**Government of India
Ministry of Railways
Research Design & Standard Organisation
Manak Nagar, Lucknow – 226 011**

Modification Sheet No. RDSO/WAG7/ELRS/MS/WAG7/ 0259

Title : Providing support to the bracket of display unit.

WAG-7 Microprocessor based Loco.

SKEL- 4522

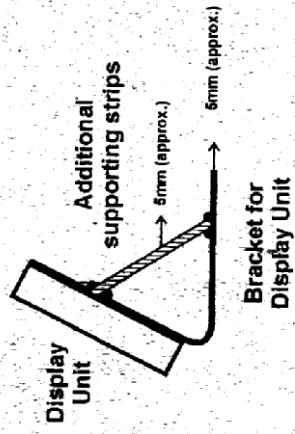
Providing extra support to the display unit to minimise the vibration.

Two strips (5 mm thick) welded to the bracket of display unit as per the sketch no. SKEL- 4522.

Two metallic strips of 5 mm thick.
